# Access Compliance Report

## Public Rights-of-Way

### (Pedestrian Signals)

Intersection ID: N/A	Main Street:	Cross Street: N/A	Location: N/A
ADA ID: 6A08AC555FFE	Signal Type: One Push Button-Non APS	Overall Compliance: No	Severity Score: BTN 1: N/A BTN 2: N/A No BTN: N/A
Codes/Mitigation Info/Possible Solution		Field Measurements/Component Compliance

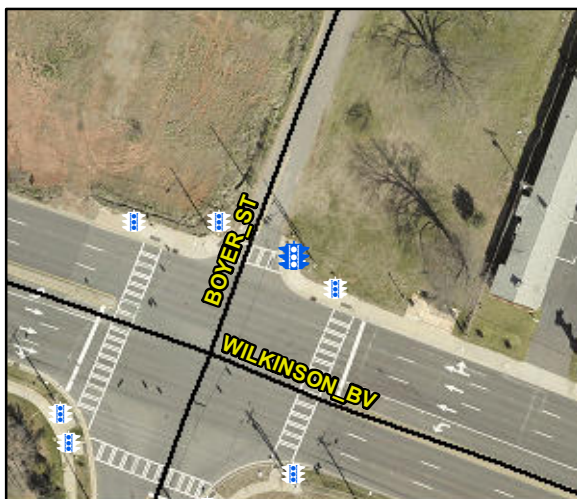
Compliance	Description	Data	Compliance	Description	Data
	Button Count	Button1	Yes	Distant to Additional Button (in)	410.0
	Additional Button Present?	Yes		Additional Button ID	99F057DF04DA
N/A	Signal Buttons Required?	N/A	N/A	Additional Ped Posts Required	N/A
	How Many Ped Street Xings?	N/A		Located In An Island/Median?	N/A
N/A	B 1 Sign Present?	Yes	N/A	B 2 Sign Present?	N/A
Yes	B 1 Sign Purpose?	Yes	N/A	B 2 Sign Purpose?	N/A
Yes	B 1 Sign Lettering & Contrast?	Yes	N/A	B 2 Sign Lettering & Contrast?	N/A
Yes	B 1 Parallel To XWalk?	Yes	N/A	B 2 Parallel To XWalk?	N/A
Yes	B 1 PAR to Button?	Yes	N/A	B 2 PAR to Button?	N/A
Yes	B 1 PAR to XWalk?	Yes	N/A	B 2 PAR to XWalk?	N/A
Yes	B 1 Clear Floor Space?	Yes	N/A	B 2 Clear Floor Space?	N/A
N/A	B 1 FWD Approach?	No	N/A	B 2 FWD Approach?	N/A
N/A	B 1 FWD Approach Constrained?	N/A	N/A	B 2 FWD Approach Constrained?	N/A
N/A	B 1 FWD Approach Reach (in)	N/A	N/A	B 2 FWD Approach Reach (in)	N/A

N/A	B 1 FWD Approach Width (in)	N/A	N/A	B 2 FWD Approach Width (in)	N/A
N/A	B 1 FWD Approach Obstruction?	Yes	N/A	B 2 FWD Approach Obstruction?	N/A
N/A	B 1 FWD Approach Obstruction Dist (in)	5.0	N/A	B 2 FWD Approach ObstructionDist (in)	N/A
N/A	B 1 PARA Approach?	Yes	N/A	B 2 PARA Approach?	N/A
N/A	B 1 PARA Approach Constrained?	Yes	N/A	B 2 PARA Approach Constrained?	N/A
No	B 1 PARA Approach Reach (in)	16.0	N/A	B 2 PARA Approach Reach (in)	N/A
No	B 1 PARA Approach Width (in)	48.0	N/A	B 2 PARA Approach Width (in)	N/A
N/A	B 1 PARA Approach Obstruction?	Yes	N/A	B 2 PARA Approach Obstruction?	N/A
N/A	B 1 PARA Approach Obstruction Dist (in)	6.0	N/A	B 2 PARA Approach ObstructionDist (in)	N/A
No	B 1 Clear Floor Space Slope (%)	2.9	N/A	B 2 Clear Floor Space Slope (%)	N/A
No	B 1 Clear Floor Space XSlope (%)	3.9	N/A	B 2 Clear Floor Space XSlope (%)	N/A
N/A	B 1 PAR Slope (%)	N/A	N/A	B 2 PAR Slope (%)	N/A
Yes	B 1 Height (in)	42.0	N/A	B 2 Height (in)	N/A

N/A	B 1 Clear Xing Direction?	Yes	N/A	B 2 Clear Xing Direction?	N/A
	B 1 Crossing Direction	To W		B 2 Crossing Direction	N/A
Yes	B 1 DistanceTo XWalk (in)	0.0	N/A	B 2 DistanceTo XWalk (in)	N/A
No	B 1 DistanceTo Curb (in)	93.0	N/A	B 2 DistanceTo Curb (in)	N/A
Yes	B 1 Diameter (in)	2.0	N/A	B 2 Diameter (in)	N/A

Possible Solutions: Replace Signal Push Button With APS Button on New Post. Remove & Relocate Sign.

PROW/ADA: TMUTCD 4e.08, R404.2, R404.3, R404.7.3, R404.7.2
